**ZONING AMENDMENT,
PLANNED UNIT DEVELOPMENT &
SUBDIVISION STAFF REPORT**

Date: September 18, 2008

| <u>SUBDIVISION NAME</u> | Frazier Park Subdivision |
| <u>LOCATION</u> | 2165 Old Shell Road (South side of Old Shell Road at the South terminus of Frazier Court) |

SITE PLAN

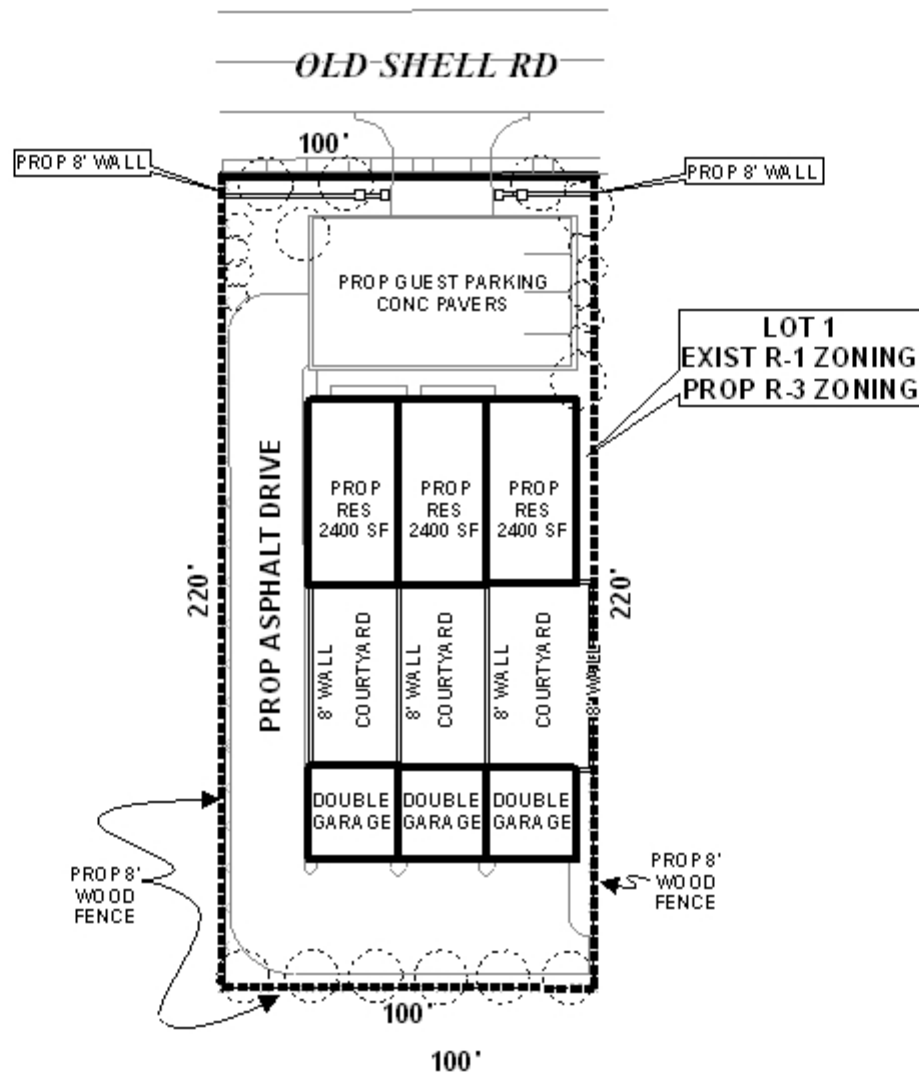
The site plan indicates that the proposed dwelling units will be 5-feet from the East property line where it abuts the B-2 district: the normal minimum side yard setback is 8 feet. An 8-foot high masonry wall is proposed along Old Shell Road, within the 25-foot minimum building setback line: 3-feet is the normal maximum height for any solid fence within the front setback area. All other setbacks appear to meet minimum requirements.

The applicant proposes 4 “guest” parking spaces between the town homes and the street, and 6 parking spaces in 3 two-car garages. A total of 5 spaces are required for 3 dwelling units. A 20-foot wide driveway will lead from the front parking area to the private garages at the rear of the property. The Zoning Ordinance normally requires a 24-foot wide driveway for two-way traffic, thus the drive will be below the width requirement. A 20-foot wide driveway may be acceptable due to the fact that it only serves 6 parking spaces and because no parking or maneuvering to serve parking would be required in the driveway area. However, fire apparatus access onto the site would not be possible due to the limited maneuvering area.

The site plan also depicts trees. It appears that the site plan is one understory tree short of full compliance with the requirements of Section 64-4.E. of the Zoning Ordinance.

Storm water detention is not depicted on the site plan, but compliance with the City's storm water and flood control regulations will be required.

A dumpster is not depicted on the site plan, however, if one will be used, it must be depicted, or a note must be placed on the site plan stating how garbage will be handled.
